February 1, 2024

MCKENNA

January 19, 2024

Subject: **Dollar Tree**
Site Plan Review and Zoning Review

1 / C1.00 **PROPOSED SITE PLAN**
SCALE: 1" = 30' - 0"

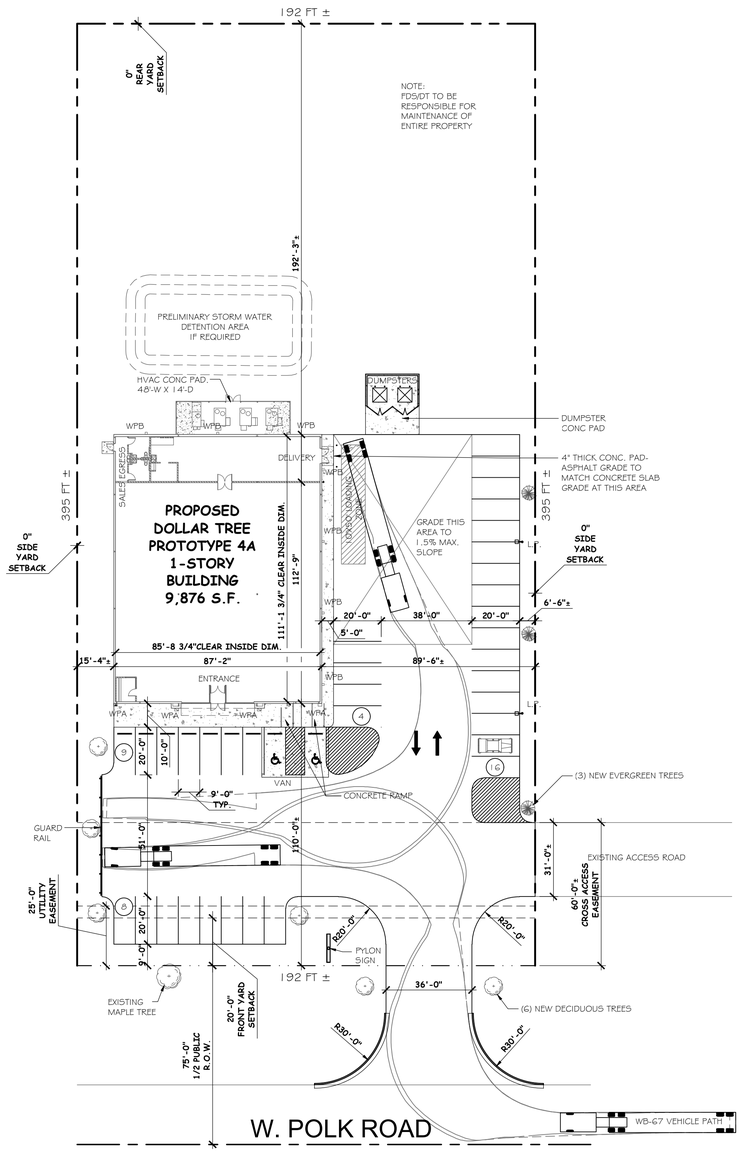
The applicant submitted a 4-page site plan that include the front elevation, sign design and height, building color scheme, parking areas, stormwater retention and runoff, truck turning radius, placement of parking spaces and non-motorized pathways, and location of the dumpster corral, among other items. The submitted site plan does appear to be consistent with the district standards listed above. The applicant did not appear to submit a lighting plan showing zero lumens at the property's edges.

- The Planning Commission should determine if the applicant should submit a lighting plan showing zero lumens at the property's edges as a condition of approval.
- The Hart City Engineer should review the stormwater runoff and retention areas of the plan for consistency with the city standards as a condition of approval.
- Any other conditions that the Planning Commission feels are relevant.

We believe that the proposed 9,876 sq. ft. Dollar Tree store on W. Polk Rd. is consistent with the B-2 zoning district, the Hart zoning map, the 2017 Hart Master Plan and the Future Land use Map. As a result, we are recommending that the Hart Planning Commission approve the project with the following conditions:

We recommend that the Hart Planning Commission make the decision to approve the construction of a Dollar Tree store on W. Polk Rd. or approve when the conditions listed above are met.
